Consultant Advice

To: Claudine Malanum, Level 33 Development Manager		Date: 23/02/2026		
Company: Wollongong Development No.8 Pty Ltd		Consultant Advice No: 001		
Email: claudine@level33.com.au		File/Ref No: Crown Square-Consultant Advice- Rev A		
Subject: Crown Square Consultant Advice regarding items flagged by Wollongong City Council.		Project Address: Crown Square, Wollongong, NSW 2500		
Issued by: Jed Hugill				
Distribution:				
To:	Cc:	Company:	Person:	Email:
☒	☐	Level 33	Claudine Malanum	claudine@level33.com.au
☐	☐			
☐	☐

Figure 3-2- Amended Architectural mark-up design based on comments made by Council

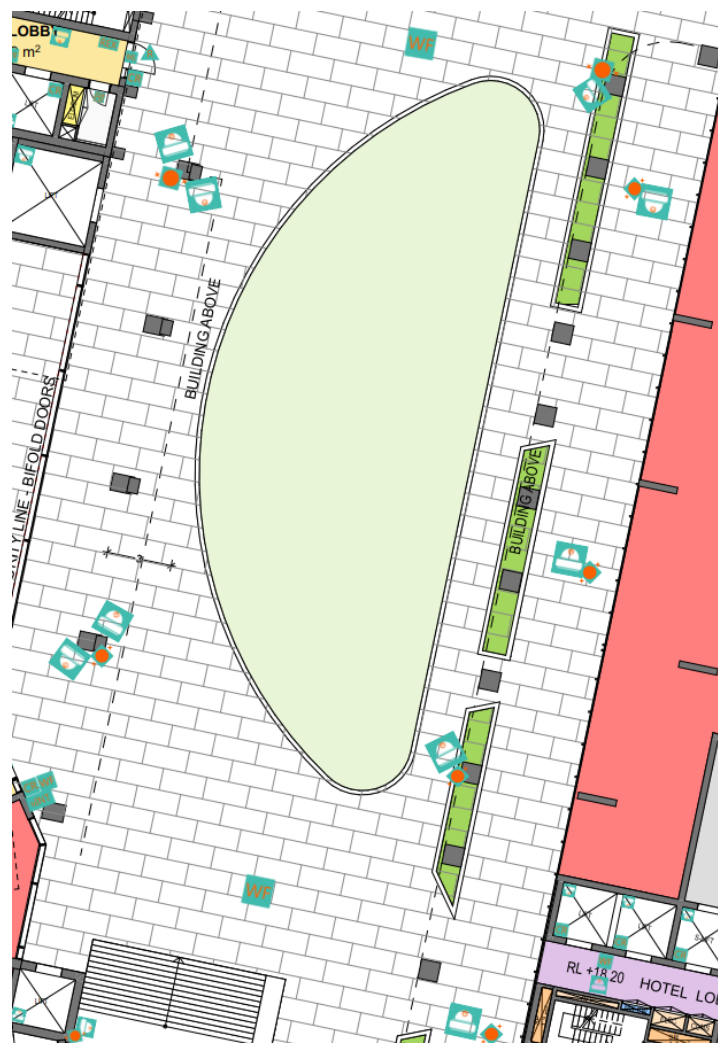
2)	Design Excellence	The columns and recessed areas are a CPTED issue, appear to compromise accessibility for those with a vision impairment, and appear to have no real purpose.

The areas formed by the building overhangs, including recessed roof and column zones, have been reviewed to understand both their functional benefits and their CPTED implications. From a positive perspective, these overhangs provide effective weather protection for pedestrians, support sheltered movement along key pathways, allow for the deployment of video surveillance and security lighting, and enable ground level retail tenancies to extend outdoor seating while remaining protected from the elements. At the same time, recessed and covered spaces can reduce natural visibility and informal surveillance, particularly where columns or roof projections create visual occlusions. In response to the matters raised by Council, as illustrated in Figure 3-2, the architectural mark-up has been amended to incorporate further enhanced video surveillance, security lighting, and wayfinding measures to clarify circulation and improve oversight. Given the open and transitional nature of these areas, where video surveillance and security lighting are not installed beneath the overhangs, pole mounted solutions are recommended. These systems should be capable of operating effectively in all weather conditions to maintain consistent coverage and visibility.

Figure 3-3- Image taken from 390844- Wollongong Developments No.8 CPTED report Rev H- pp 61

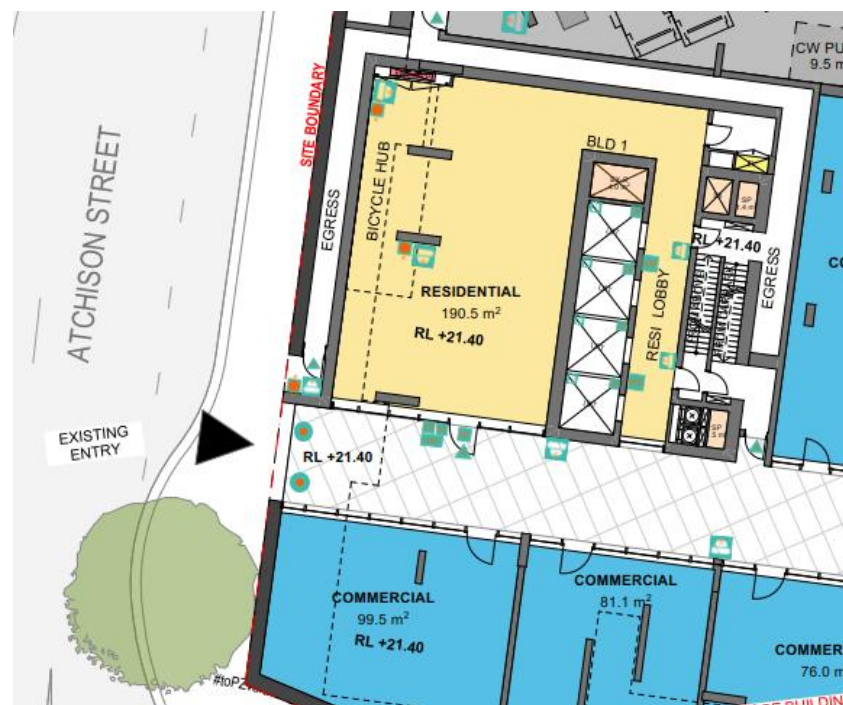
3)	Design Excellence	The corridor entry configuration at the Atchison Street frontage is not supported due to CPTED concerns. It leads to commercial space that would likely be closed in the evening or difficult to tenant. This corridor space would be better occupied by a more generous residential lobby area similar to that approved under DA-2021/957 with a controlled entry point at Atchison Street.

The corridor entry configuration at the Atchison Street frontage has been reviewed in response to the CPTED concerns raised. The current arrangement provides a transitional space between the street interface and internal areas; however, such corridors can experience reduced activation outside of business hours where adjoining commercial tenancies are closed or underutilised. This condition may limit passive surveillance and reduce informal oversight during evening periods.

The alternative approach suggested, involving an extension of the residential lobby to occupy this frontage, presents several CPTED advantages. A larger residential lobby with a controlled entry point would support stronger access control, improve territorial definition, and reduce the potential for spaces that could be misused for unintended activities. From a crime prevention perspective, this approach strengthens first and second generation CPTED outcomes by consolidating entry points and clarifying public and private domains.

Should the design be amended in this manner, no adverse security implications are identified. The proposal would instead enhance control, visibility and defensible space, provided appropriate access control, lighting and surveillance measures are integrated into the lobby design.
